## **Special Meeting of the Council**

# **MINUTES**

<b>Date:</b>	<b>Tuesday, 12 February 2019</b>
<b>Time:</b>	<b>6:30pm</b>
<b>Location:</b>	<b>Council Chamber, Civic Centre 699 Doncaster Road, Doncaster</b>

### 5.1 Application for Review P2044/2018 of Planning Application PL17/027801 for 14 & 16 Clay Drive, Doncaster (Amended Plans for VCAT)

Figure 02: Amended Plans

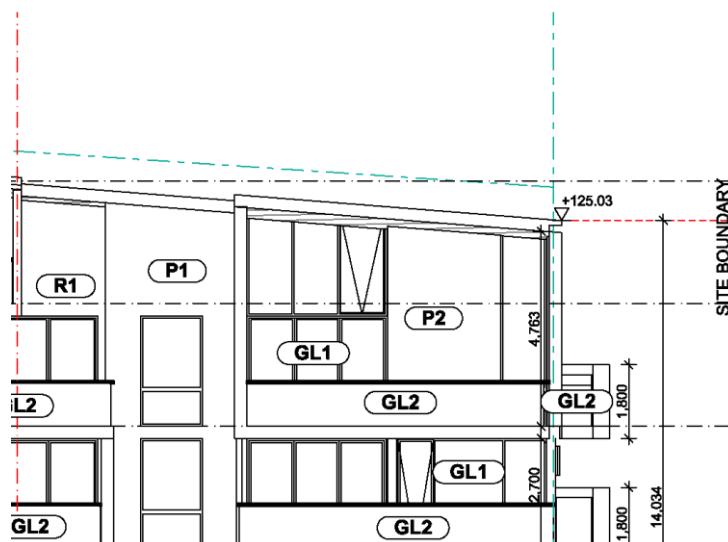
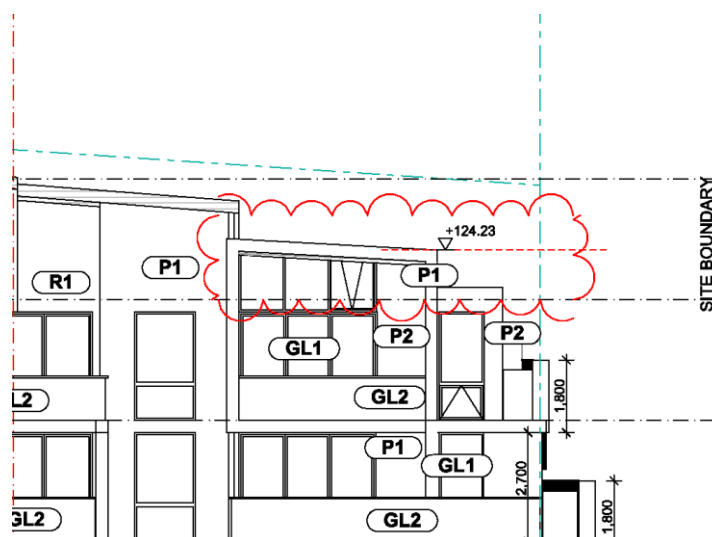
- 8.15 The roof form at the southern side of the building has been modified to a flat roof form, where one continuous roof pitch was previously provided across the entirety of the building. This has allowed a reduction in the design element that frames Apartment 303's western terrace and a subsequent decrease to the building height on the southern elevation (by between 0.84 metres and 1.68 metres) resulting in a building height at the southern end of 12.4 metres (from the previous 14.04 metres). The following images provide a demonstration of the stepping introduced to the amended proposal:

- 8.16 The increase to setbacks to the third floor level walls and terraces at both the southern and western elevations creates a recessing from the levels below where previously a sheer wall presentation was observed. This results in a notable reduction in visual bulk and evident transition in building form to the southern elevation when viewed from both the streetscape and the adjoining property to the south.

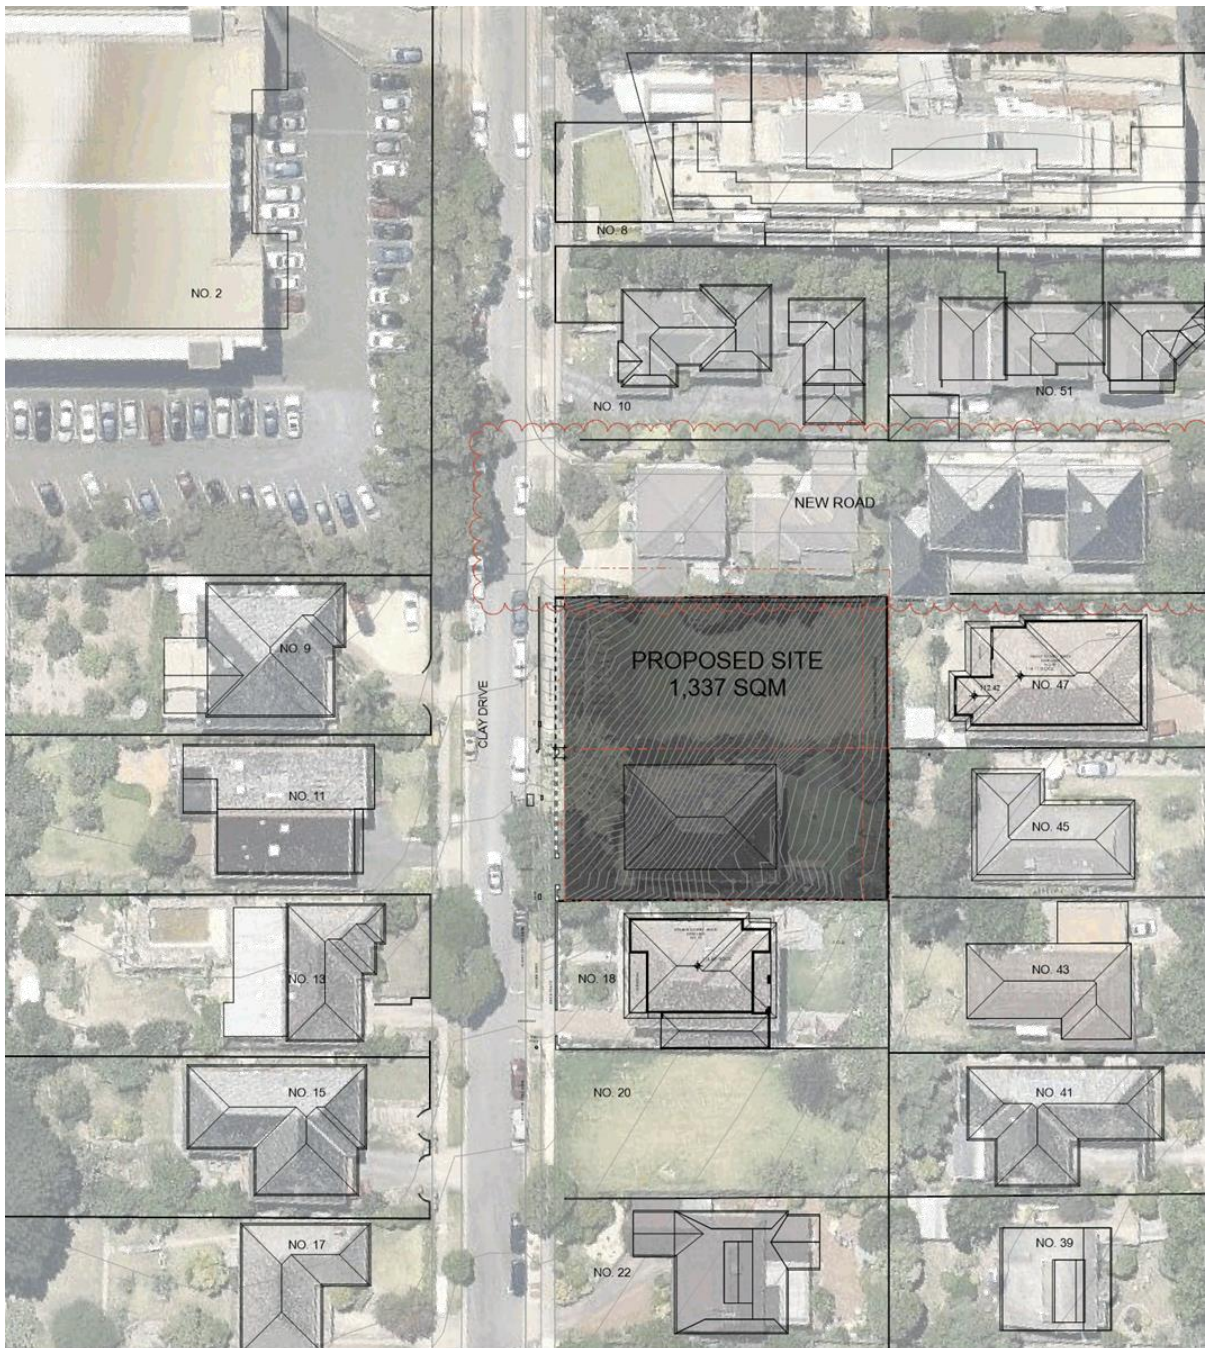
- 8.53 The proposal originally failed to detail visibility splays on the ground floor plan to demonstrate adequate site lines when exiting the basement. The amended plans adequately detail visibility splays in accordance with Design Standard 1 of Clause 52.06 Car Parking of the Scheme.

- 8.54 It is noted that the location of the crossover has not changed and will require removal of a mature street tree. Considering the topography of the land, the crossover has been sited in the most logical location for basement access, at the lowest point of the land. On balance, removal of a street tree to accommodate a development of this nature is an acceptable outcome subject to replacement planting.

**SECOND FLOOR PLAN**

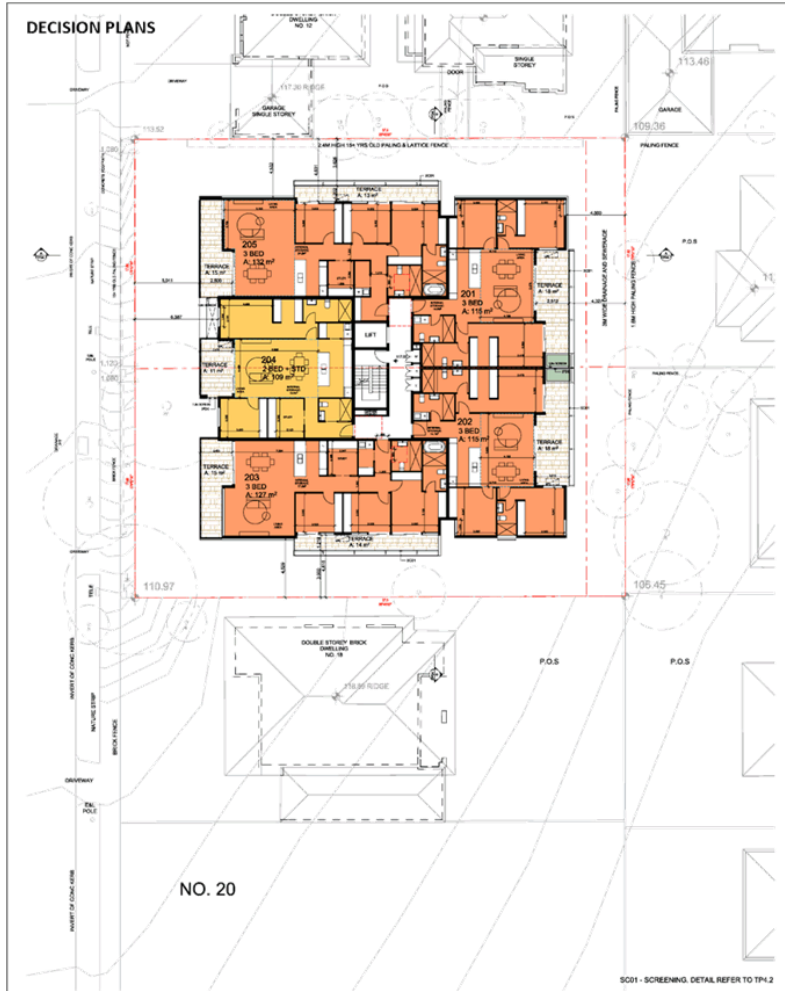
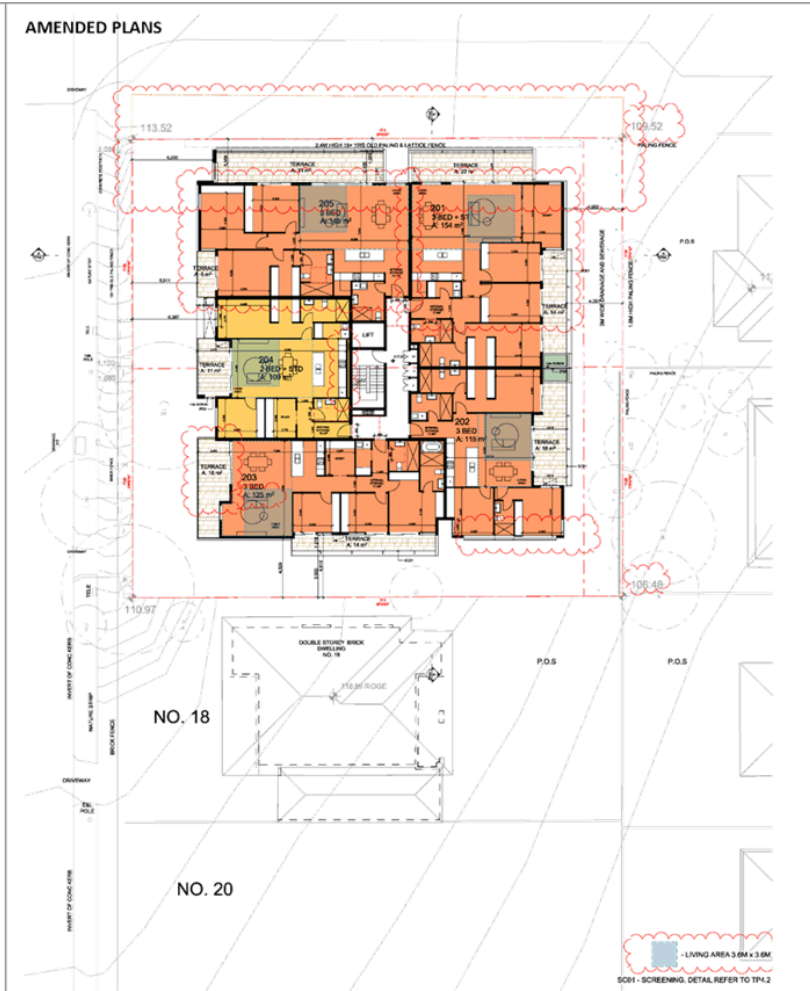
**Key Changes:**

- Reorientation of the building further north, reducing the northern boundary setbacks
- Reconfiguration of apartment rooms and layouts

- Addition of terraces to the northern side of the building
